# UNITED STATES PATENT AND TRADEMARK OFFICE

APPLICATION NO.	FILING DATE	FIRST NAMED INVENTOR	ATTORNEY DOCKET NO.	CONFIRMATION NO.
10/666,950	09/18/2003	Susan Olvey	OLV-100R	7054

<b>Office Action Summary</b>	<b>Application No.</b> 10/666,950	<b>Applicant(s)</b> OLVEY, SUSAN	
	<b>Examiner</b> Philip Gabler	<b>Art Unit</b> 3637

## **DETAILED ACTION**

**FIG. 1****FIG. 2****FIG. 3****FIG. 4****FIG. 5****FIG. 9**

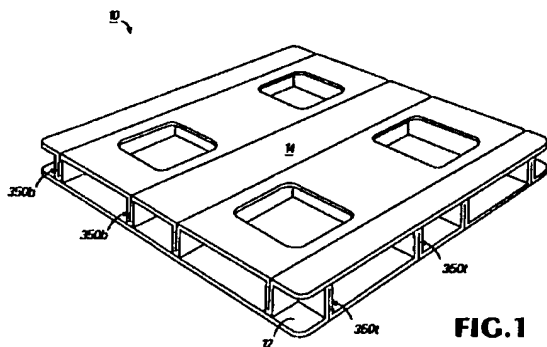
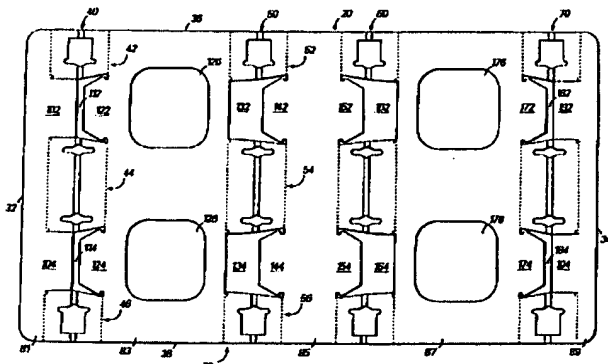
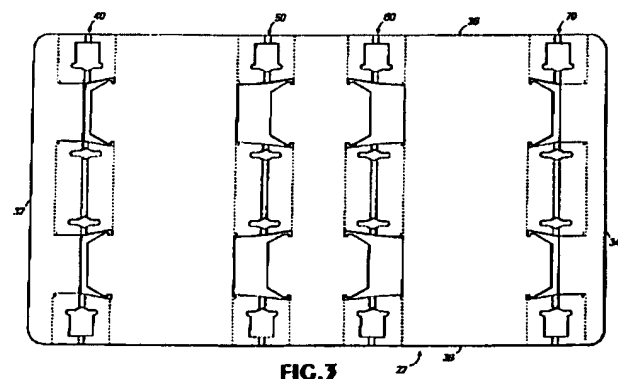
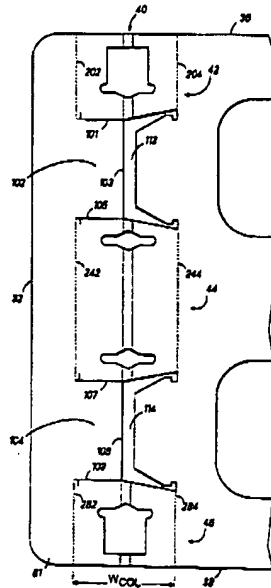
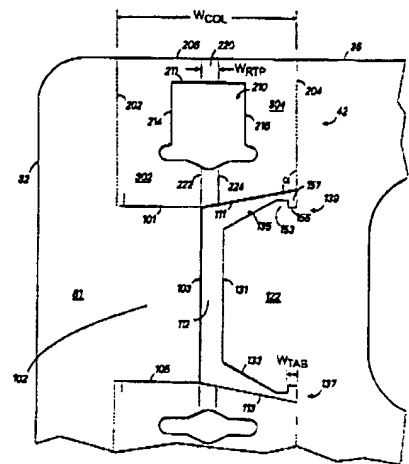
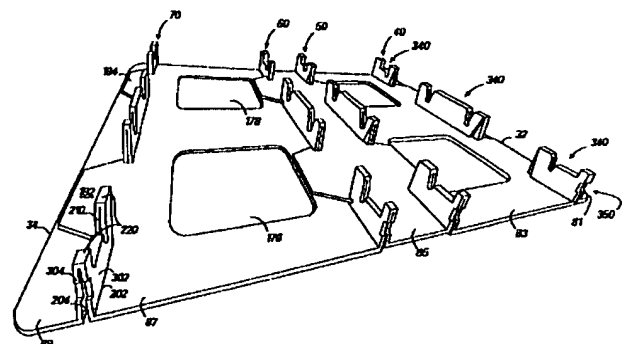
11. Regarding claims 1 and 4, Ogilvie (Figures 1-5 and 9) discloses a force resisting corrugated assembly foldably constructed from a generally flat blank, the blank having top and bottom ends and sides upon folding, said assembly comprising: a first assembled frame (20), said first frame comprising at least two jack panels (83, 87); at least three ribs (formed by 40, 50, 60), said ribs formed by folding said blank at predetermined locations and locked into place by folding lock assemblies (122, 142, etc. and associated components); and first and second edge panels (81, 89) defined on first and second ends, respectively, of said first frame; and a second frame (22), said second frame comprising at least two jack panels; at least three ribs, said ribs formed by folding said blank at predetermined locations and locked into place by folding lock assemblies; and first and second edge panels defined on first and second ends, respectively, of said second frame (the jack panels, ribs, etc. as in the first frame); wherein said ribs of first and second frames comprise locking slots (210, etc.); wherein said first and second frames are brought together in a perpendicular fashion such that the ribs of the first frame lock into place with the ribs of the second frame (see figures).

12. Regarding claim 2, Ogilvie further discloses folding lock assemblies comprise wing tabs (153) to secure said ribs into place.

13. Regarding claim 3, Ogilvie further discloses two jack panels (83, 87) and four ribs (formed from 40, 50, 60, 70).

14. Regarding claim 5, Ogilvie further discloses said edge panels of said first and second frames are folded over (at 202, etc.) and secured into place (by 102, etc.) before, during, or after the ribs of said first and second frames are locked into place.

15. Regarding claim 6, Ogilvie further discloses said first and second frames comprise tab locks (153) defined near the periphery of said first and second frames; and edge panels comprise tab holes (formed by 101, etc.); wherein said tab locks and said tab holes are positioned such that tab locks are pushed through tab holes upon edge panels being secured into place, whereby said tab locks increase the holding strength of said edge panels.

Haywood et al. '241 Figures 2 and 8

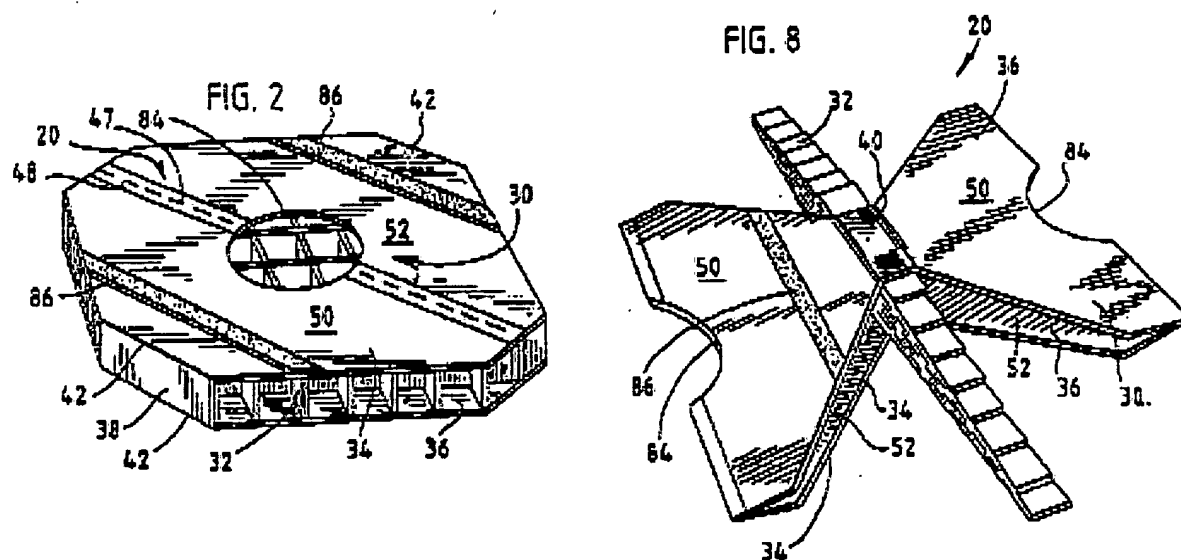
20. Claims 7 and 12 are rejected under 35 U.S.C. 102(b) as being anticipated by Haywood et al. (US Patent Number 5484241). Haywood (Figures 2 and 8) discloses a force resisting corrugated assembly foldably constructed from a generally flat blank, said assembly configured to be assembled into the shape of an octagon.

Chilcutt '181 Figure 2

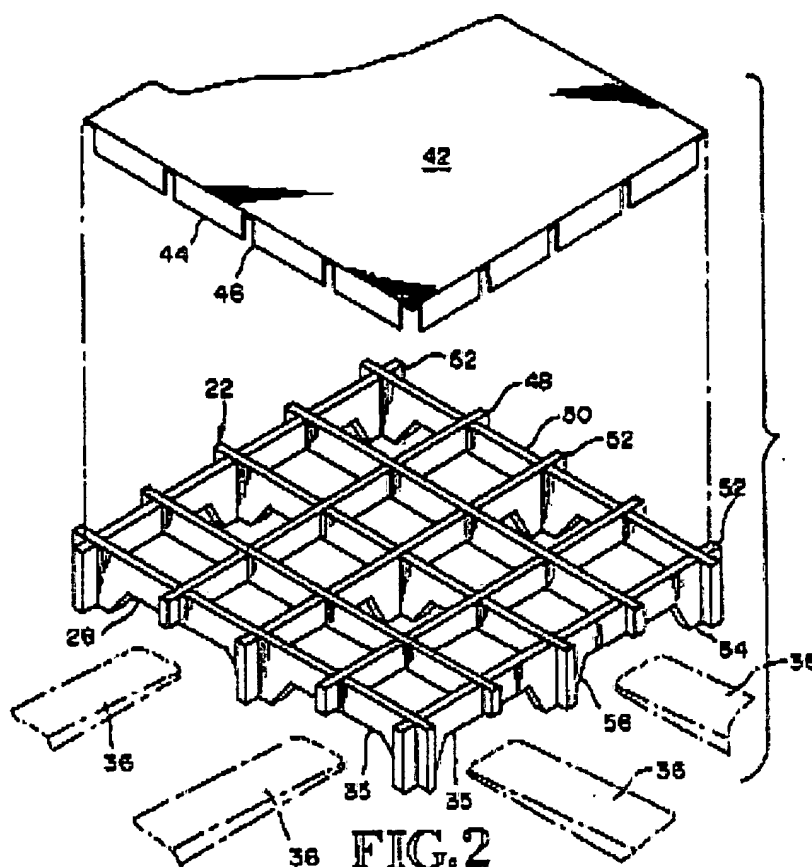
21. Claims 9-11 are rejected under 35 U.S.C. 102(b) as being anticipated by Chilcutt (US Patent Number 6155181). Chilcutt (Figure 2) discloses a generally flat, rectangular corrugated tray (42) comprising a plurality of tab locks (edges of 46) and a wall (44) on all four sides, and which could be attached to an assembly as recited in claim 3.
